To: T10 Technical Committee
From: Rob Elliott, HP (elliott@hp.com)
Date: 18 January 2005
Subject: 05-018r1 SAS-1.1 Discover process disable unused entries

sas1r07 - Serial Attached SCSI 1.1 revision 7

Figure 2 — Expander route index levels example

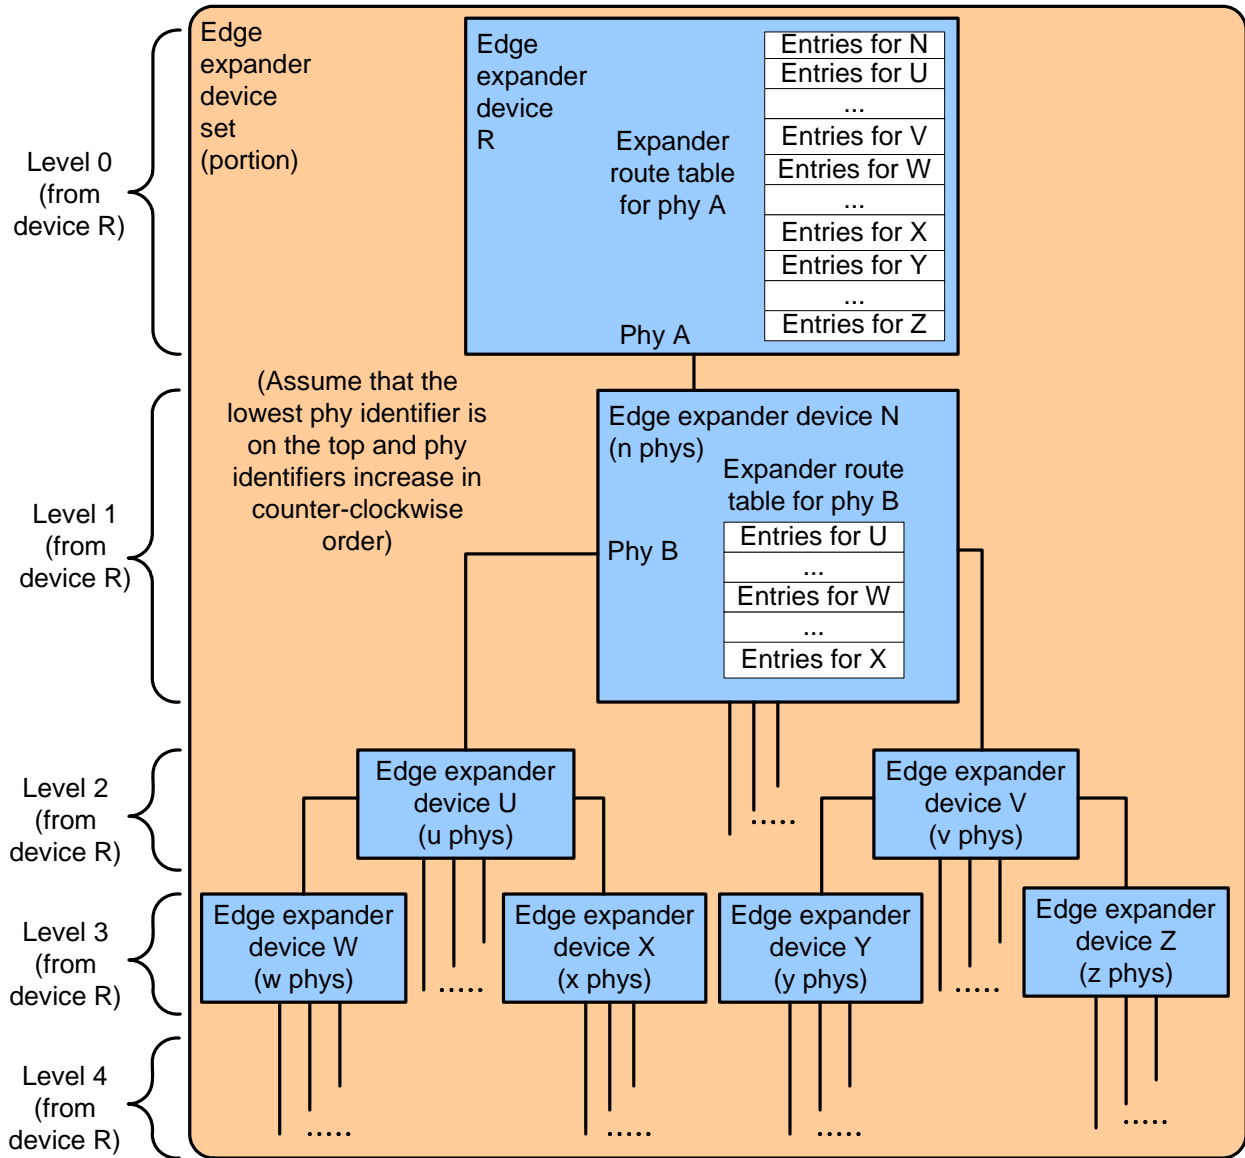
After the expander route table has been configured with entries for all levels of edge expander devices, all remaining expander route table entries, if any, shall be disabled (i.e., the ROUTED SAS ADDRESS field shall be set to 00000000 00000000h and the DISABLE EXPANDER ROUTE ENTRY bit shall be set to one). The management application client is not required to disable entries if the topology of expander devices has not changed.

Figure 2 shows a portion of an edge expander device set, where phy A in the root edge expander device is being configured.

Figure 3 — Expander route index levels example with fanout expander device

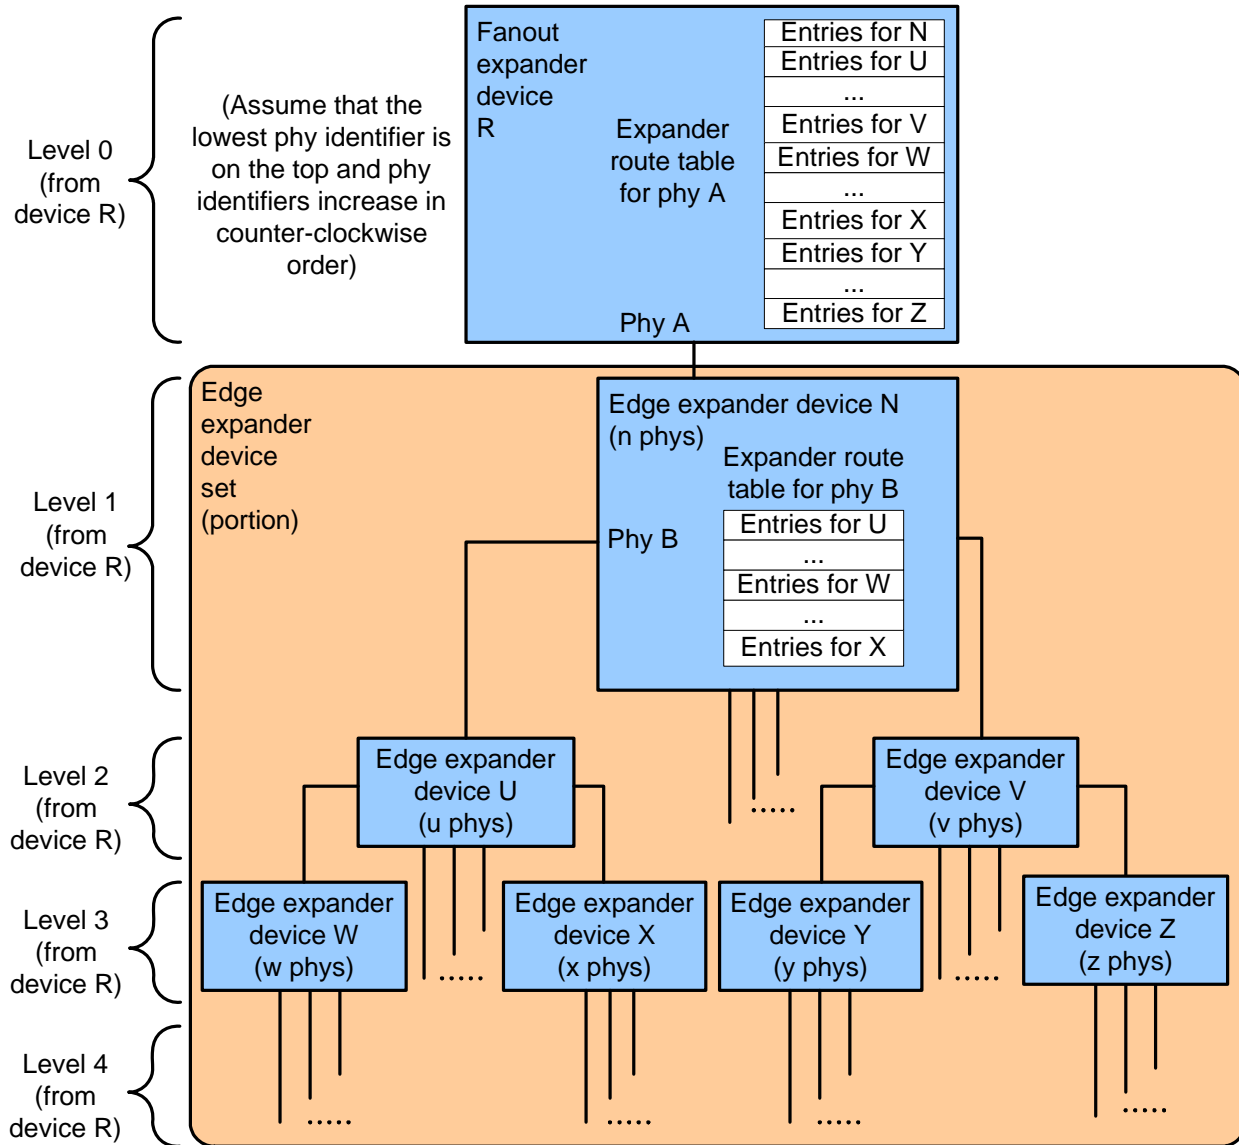
Figure 3 shows a fanout expander device and an edge expander device set, where phy A in the fanout expander device is being configured.

Figure 4 — Expander route index order example

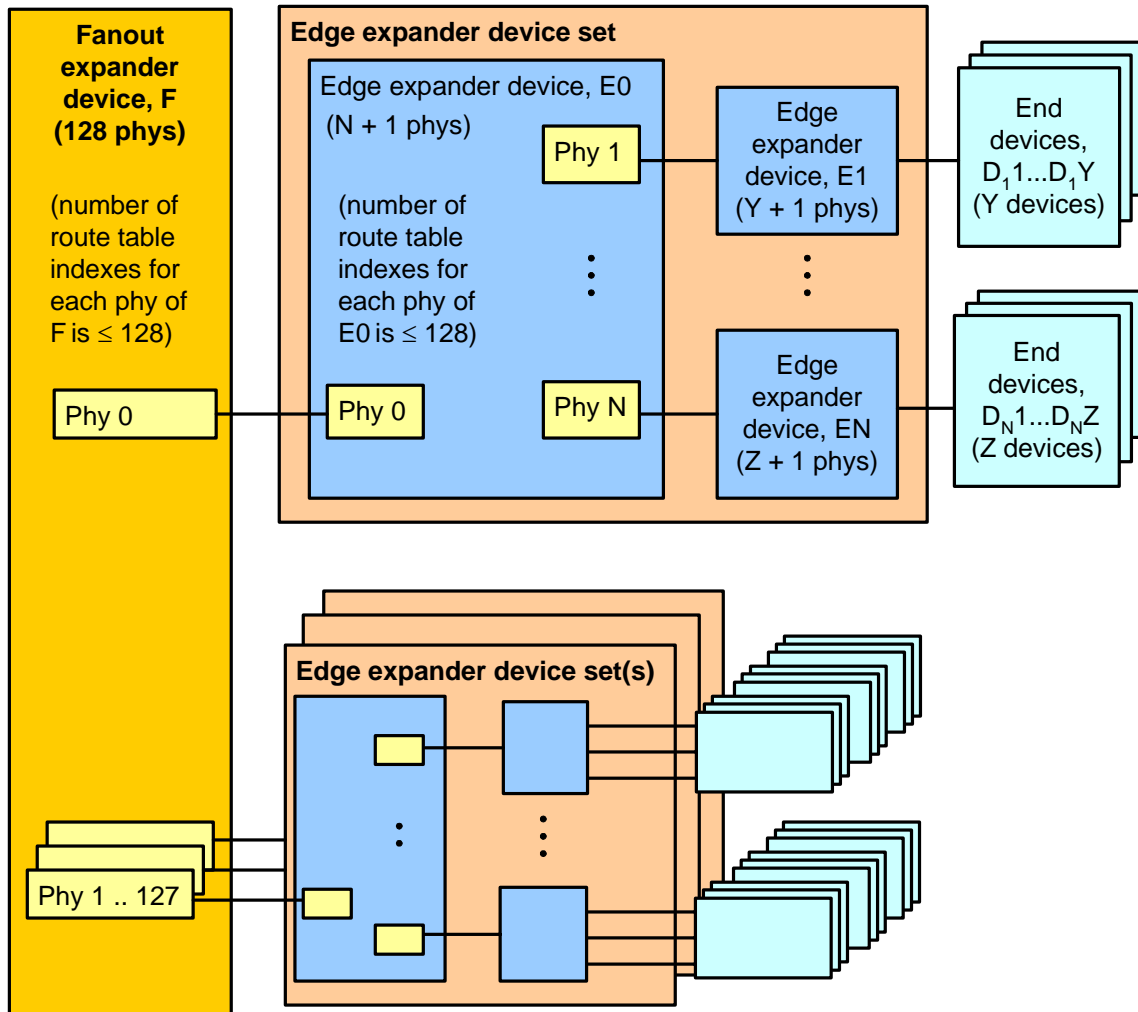
Table 3 shows the expander route index order for the edge expander E0 phy 1 in figure 4.

Expander route index	Expander route entry contents
Level 1 entries	
0	SAS address (e.g., D ₁ 1) of the device attached to phy 1 of edge expander device E1
1	SAS address (e.g., D ₁ 2) of the device attached to phy 2 of edge expander device E1
...	...
Y - 1	SAS address (e.g., D ₁ Y) of the device attached to phy Y of edge expander device E1
Level 2 and beyond: no entries	
<u>Disabled entries</u>
